MAYFLOWER PLATINUM

Details of Additions & Alterations

Flat No	907	Block no.	'A'
Flat Area	1800 sft	Type	Deluxe / Luxury
Buyer Name	Mazahar Ali Baig Mirza / Shaik Farheen Fathima		
Phone No.	9049988064 / 7507815870	Email	MIRZAMAZAHAR@GMAIL.COM

WORKING DRAWING OF FLAT.NO.A-7

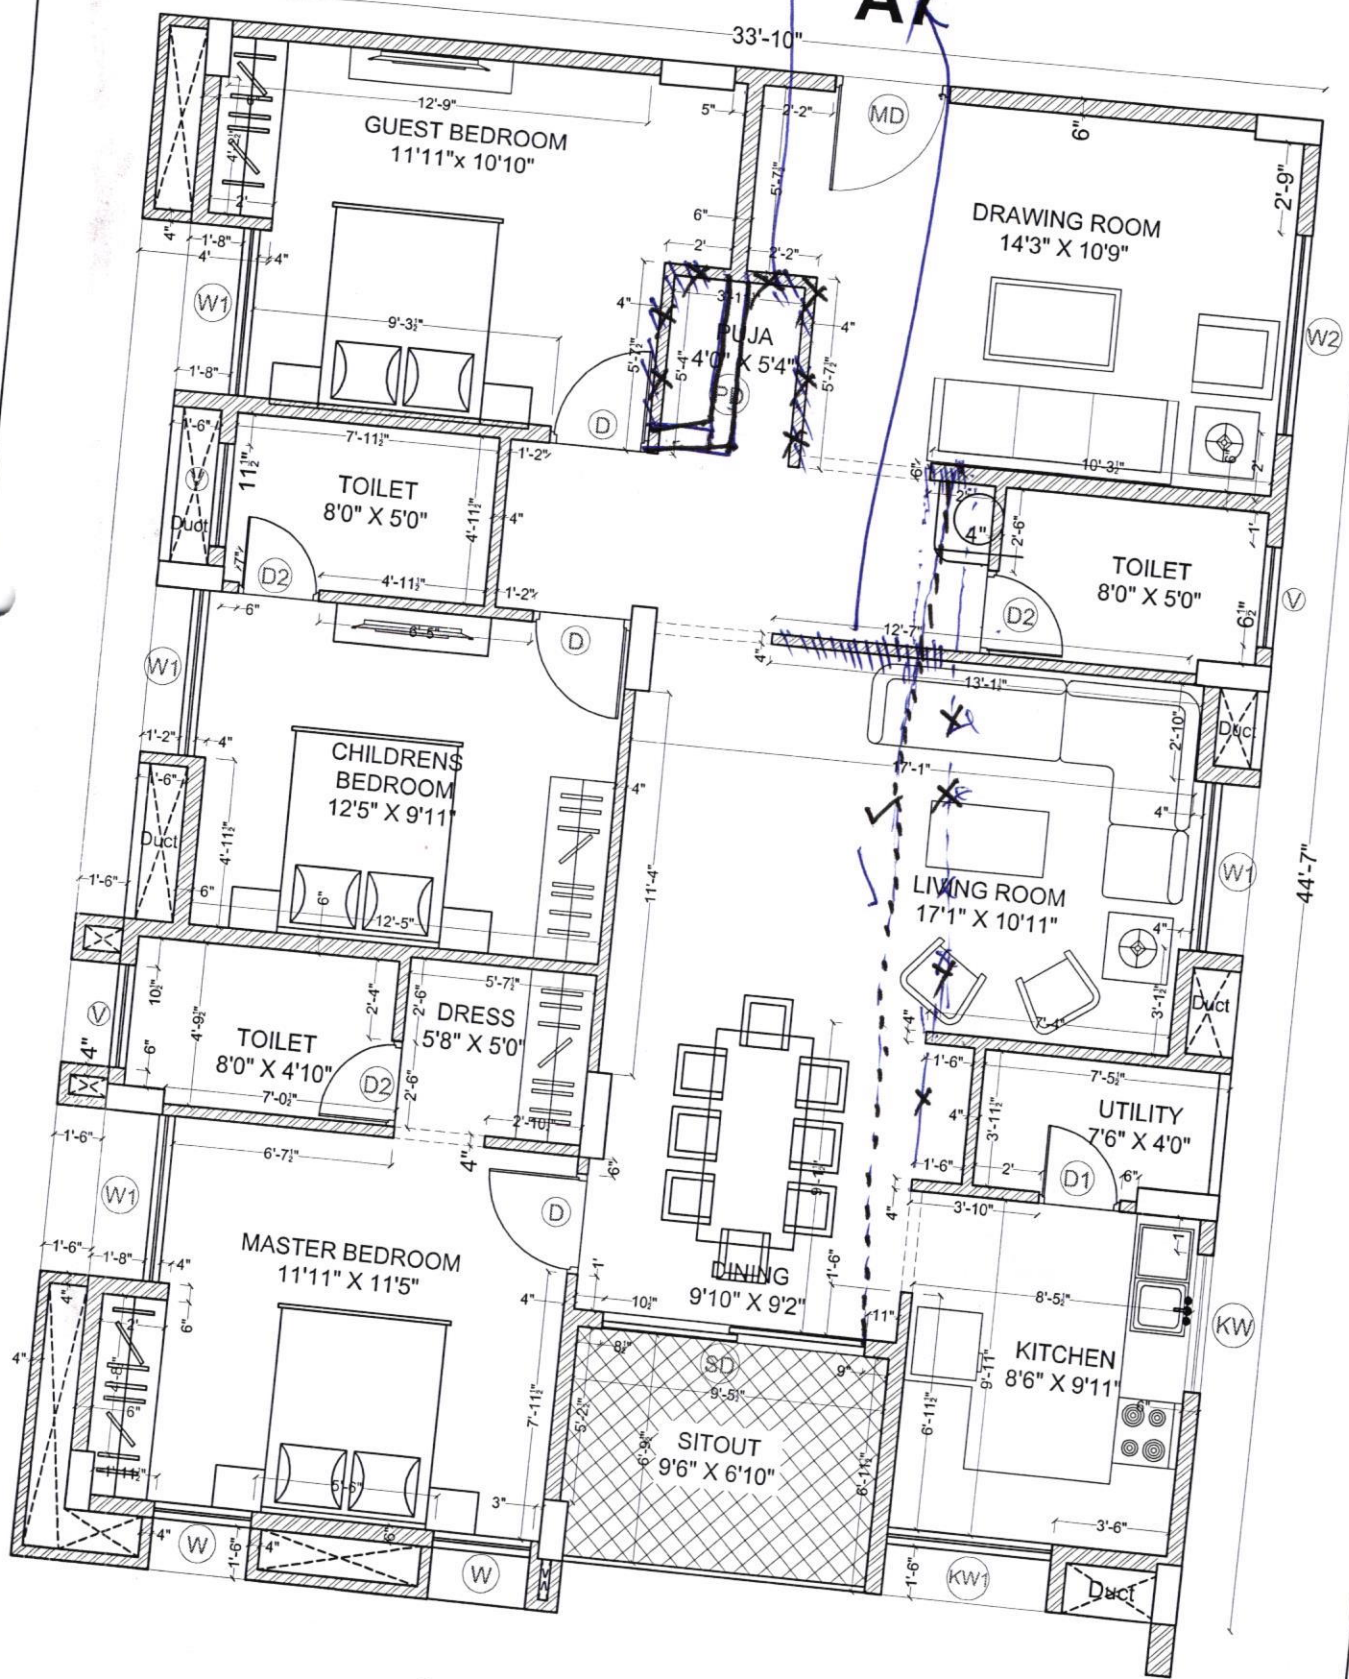
Changes in kitchen platform: (mark on plan)

- ① Kitchen tile dado - $3'0"$ LA no tiles at dado
- ② Kitchen grease will be made by customer

Other Changes:

- ① All bedrooms, drawing, living - 3 track window
- ② MBR - $3'0" \times 4'0"$ - 2 track

To be removed
